# Access Compliance Report

## Public Rights-of-Way

Intersection ID: 49346	Main Street: BLUE_JUNCTION_RD	Cross Street: FIRESPIKE_RD	Location: SW
ADA ID: F2C0B26F1B8E	Ramp Type: Perp	Initial Pass/Fail: Fail	Overall Compliance: No
Severity Score: 10			
Codes/Mitigation Info/Possible Solution		Field Measurements/Component Compliance

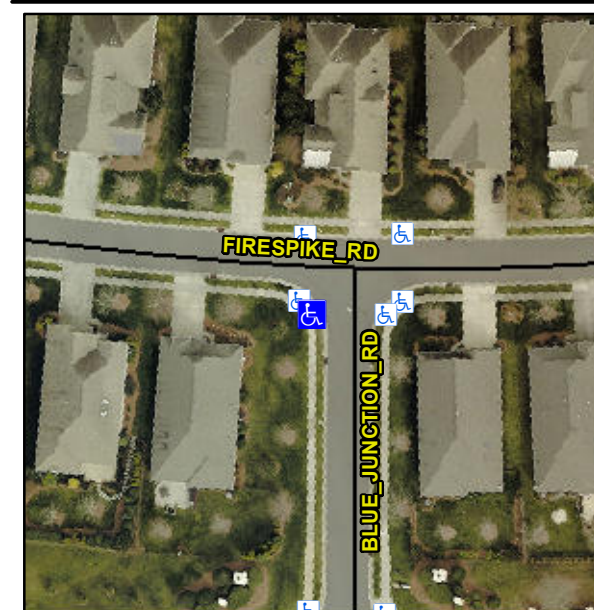
**Not Found, R304.5.1, R304.5.3**

Compliance	Description	Data	Compliance	Description	Data
N/A	Ramp Length (in)	47.0	Yes	Ramp Slope (%)	6.8
No	Ramp Width (in)	47.5	No	Ramp XSlope (%)	4.1
N/A	Flare Type LT	N/A	N/A	Flare Type RT	N/A
N/A	Flare Slope LT (%)	N/A	N/A	Flare Slope RT (%)	N/A
N/A	Flare Traversable LT?	N/A	N/A	Flare Traversable RT?	N/A
N/A	Landing Length (in)	N/A	N/A	DWS Provided?	N/A
N/A	Landing Width (in)	N/A	N/A	DWS Contrast?	N/A
N/A	Landing Slope (%)	N/A	N/A	DWS Length (in)	N/A
N/A	Landing X Slope (%)	N/A	N/A	DWS Full Width?	N/A
N/A	Landing Curb? (Y/N)	N/A	N/A	DWS Offset (in)	N/A
N/A	Shared Landing?	N/A			
N/A	Gutter Ponding?	N/A	N/A	Gutter Slope (%)	N/A
N/A	Gutter Lip Ht (in)	N/A	N/A	Gutter X Slope (%)	N/A
N/A	Painted X Walk1?	No	N/A	Painted X Walk2?	N/A
	X Walk 1 Direction	To SE		X Walk 2 Direction	N/A
N/A	X Walk 1 Width (in)	N/A	N/A	X Walk 2 Width (in)	N/A
	X Walk 1 Slope (%)	0.6		X Walk 2 Slope (%)	N/A
	X Walk 1 X Slope (%)	3.4		X Walk 2 X Slope (%)	N/A

**Remove & Replace Entire Ramp.**
